SERVICE BULLETIN

SERVICE BULLETIN		No.: ESB-98E35-501																	
		Date: 1999-09-30	<Model> <M/Y> (EC,EXP) ECLIPSE 98-10 (D30)																
Subject: CORRECTION OF TIME WHEN ACTUATOR IS FORCE-DRIVEN FOR ACTUATOR TEST																			
Group: SERVICE BRAKE																			
CORRECTION		 O. Kai - E.V.P. & G.M. After Sales Service Dept.																	
1. Description: In the ABS hydraulic unit inspection, time when the actuator is driven for the actuator test has been corrected.																			
2. Applicable Manuals:

Diagnosis Table

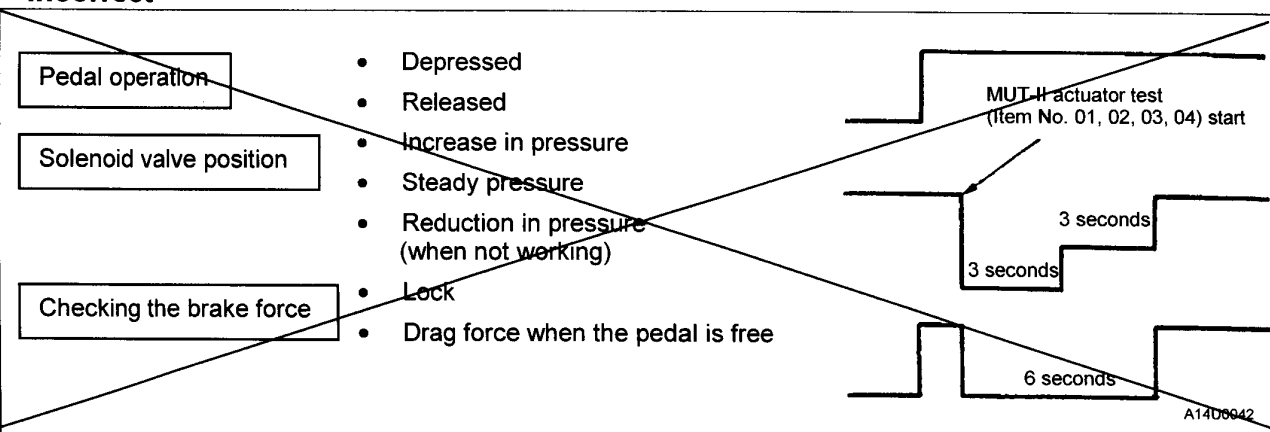
<Incorrect>

No.	Operation	Judgement – Normal	Judgement – Abnormal	Probable cause	Remedy
01	(1) Depress brake pedal to lock wheel.	Brake force released for 6 seconds after locking	Wheel does not lock when brake pedal is depressed	Clogged brake line other than hydraulic unit	Check and clean brake line
02	(2) Using the MUT-II, select the wheels to be checked and force the actuator operate.			Clogged hydraulic circuit in hydraulic unit	Replace unit hydraulic assembly
03	(3) Turn the selected wheel manually to check the change of brake force.		Brake force is not released	Incorrect hydraulic unit brake tube connection	Connect correctly
04				Hydraulic unit solenoid valve not functioning correctly	Replace unit hydraulic assembly

<Correct>
